SJX 1259U

Our ref: CS/FCI18022588/T1vb

INITIAL INSPECTION REPORT OF VEHICLE NO SJX 1259U

ADJUSTMENT ON REPAIR COST FOR VEHICLE NO. SJX 1259U

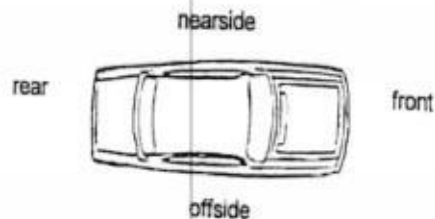
The vehicle sustained damages at the rear n/s portion

Damages Consistent

Workshop Estimate Amount	: S\$7,487.83
Revised Estimate Amount	: S\$2,655.12
"Check" Items Amount	: S\$
Total	: S\$
Market Value	: S\$
LTA Reimbursement Value	: S\$
Nett Value	: S\$
